# United States Patent and Trademark Office

APPLICATION NO.	FILING DATE		FIRST NAMED INVENTOR	ATTORNEY DOCKET NO.	CONFIRMATION NO
10/018,307	10/29/2001		Josef Scharmuller	SCHARMULLER -1 PCT	4882
	7590	05/27/2003			
Collard & Roe 1077 Northern Boulevard Roslyn, NY 11576				EXAMINER	
				ROYAL, PAUL	
				ART UNIT	PAPER NUMBER
				3611 .	
				DATE MAILED: 05/27/2003

#### **DETAILED ACTION**

FIG. 2

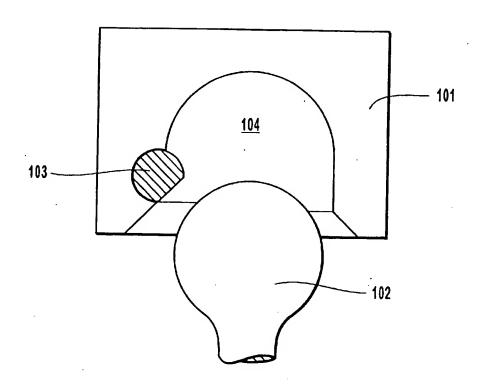
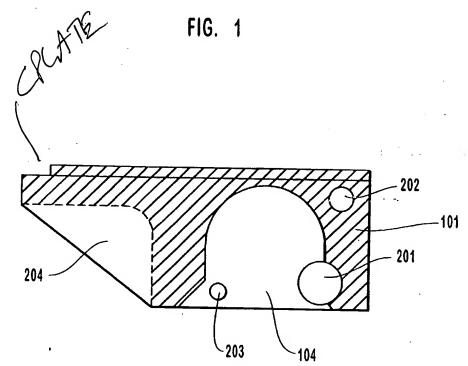
Coilbert et al. teaches a coupling device for a towing vehicle and a trailer, the coupling device comprising coupling ball (102) and a moulded article (101), having a ball socket (104) and a connecting plate (CPLATE, see Examiner's annotated Figure 2), said moulded article made of a ferrous material and presenting a casting crust at least on the interior of the socket, see claim 8.

Note it is well known that in the production of a cast steel moulded article (hitch coupler body) a crust forms during the casting process.
